UniStar Nuclear Energy, NRC Docket No. 52-016
Response to Request for Additional Information for the

Calvert Cliffs Nuclear Power Plant, Unit 3, RAI No. 106, AC Power Systems (Onsite)

Response to NRC Request for Additional Information RAI No. 106, Questions 08.03.01-1 and 08.03.01-2, AC Power Systems (Onsite)
Calvert Cliffs Nuclear Power Plant, Unit 3

Figure 8.3-1—{CCNPP Unit 3 Emergency Power Supply System Single Line Drawing} (Page 1 of 3)

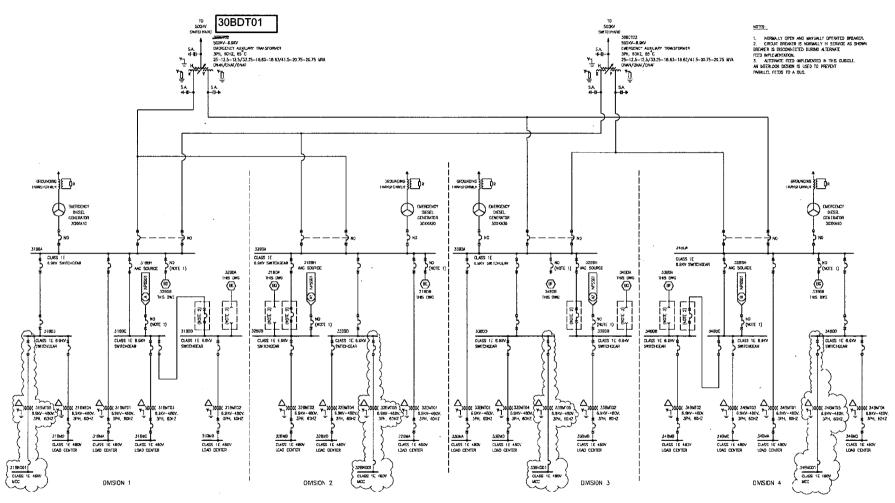
FSAR Figure 8.3-1 contains a typo because it shows two 30BDT02 transformers. The Applicant should correct this typo by changing Figure 8.3-1 to show one 30BDT01 transformer and one 30BDT02 transformer.

FSAR Chapter 8, Figure 8.3-1, Emergency Power Supply System Single Line Drawing (Sheet 1 of 3), will be revised to change the emergency auxiliary transformer on the left side of the figure from 30BDT02 to 30BDT01.

FSAR, Chapter 8, Figure 8.3-1 (Sheet 1 of 3), will be revised as shown on the following figure in a future COLA revision:
